UNITED STATES PATENT AND TRADEMARK OFFICE

| APPLICATION NO. | FILING DATE | FIRST NAMED INVENTOR | ATTORNEY DOCKET NO. | CONFIRMATION NO. |
|--|-------------|----------------------|---------------------|------------------|
| 10/804,926 | 03/19/2004 | Kasra Khazeni | KLAP1679US | 8219 |

Office Action Summary

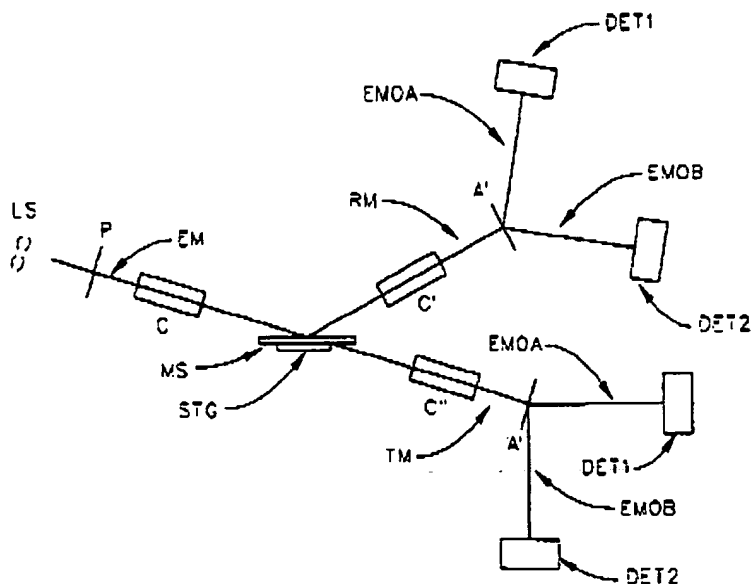
Johs discloses an optical measuring system (Figure below) comprising:
a laser (LS) configured to generate an intensity stabilized light beam;
an optical system (P) for directing the beam (EM) to a spot on a substrate (MS) being evaluated;
a detection system configured to receive and detect light reflected from the substrate (MS);

said detection system including polarizers (A') to convert the reflected beam to s and p polarized light (EMOA and EMOB) and detectors (DET 1 and DET 2) to read the information content of the s and p polarized reflected beams; and,

compensators (C, C') to compensate for unwanted phase shifts between the s and p beams introduced by other optical components. (column 12, lines 13-32 and 54-20)

The polarizer (A') of the system of Johs can be a Wollaston prism polarizer (column 13, lines 41-51 and Figure 3). A Wollaston prism polarizer splits an input beam into two separate beams with different directions of polarization (i.e. an s and a p polarized beam.)
